MFN 07-015

Subject: Response to Portion of NRC Request for Additional Information Letter No. 76 Related to ESBWR Design Certification Application - Instrumentation and Control - RAI Numbers 7.1-43, 7.2-33, 7.2-34, 7.2-36, 7.2-41 through 7.2-49, 7.3-3, through 7.3-6, 7.3-8, 7.3-9, 7.7-2, 7.7-5, and 7.9-15

Enclosure 1

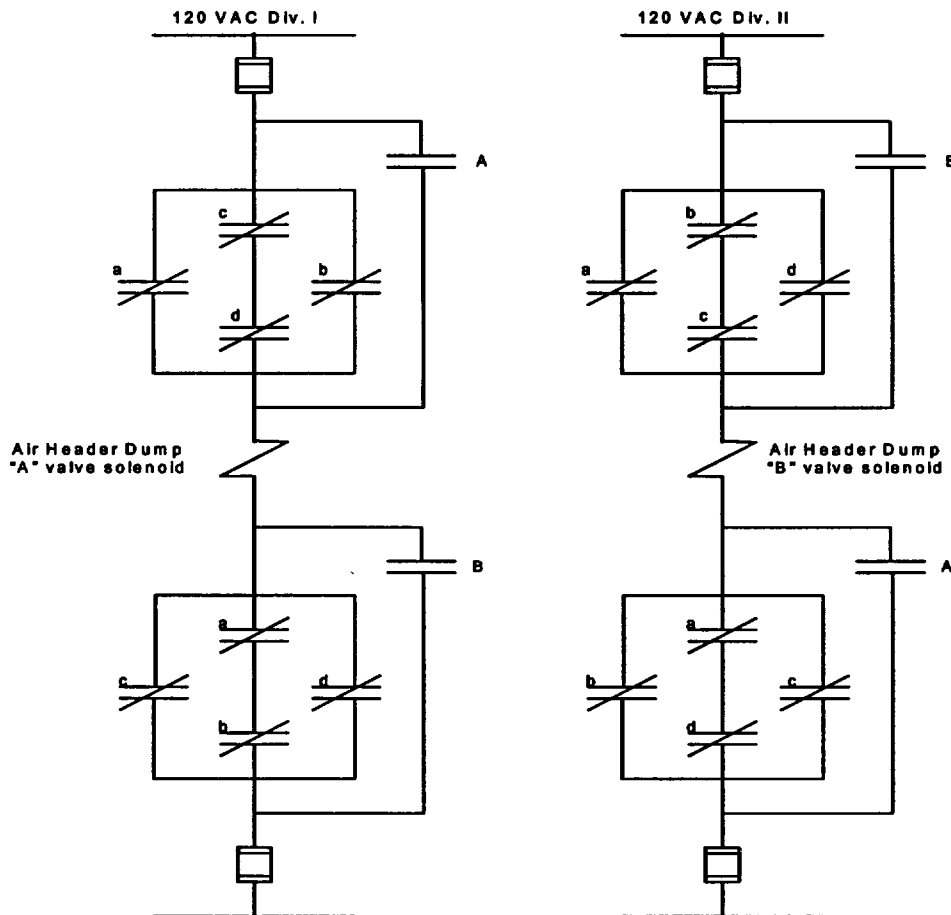
In DCD, Tier 2, Revision 1, Section 7.2.1.2.4, "Divisions of Trip Actuators", normally open relay contacts are described for the ESBWR, for energization of the air header dump valve solenoids to energize. Provide a Power Distribution Diagram which shows the normally closed scheme for that design.

The backup scram logic circuitry performs RPS backup scram functions by operating air header dump valve solenoids. The power distribution diagram showing normally closed load drivers (a through d) arranged in 2-out-of-4 logic is provided in the following figure. The load drivers are located between the air header dump valve solenoids and 120 VAC class 1E power source so that, on a reactor trip (coil de-energized), the load driver contacts close to energize the air header dump valve solenoids. Holding contacts A and B keep the solenoids energized till the backup scram logic circuitry is reset.
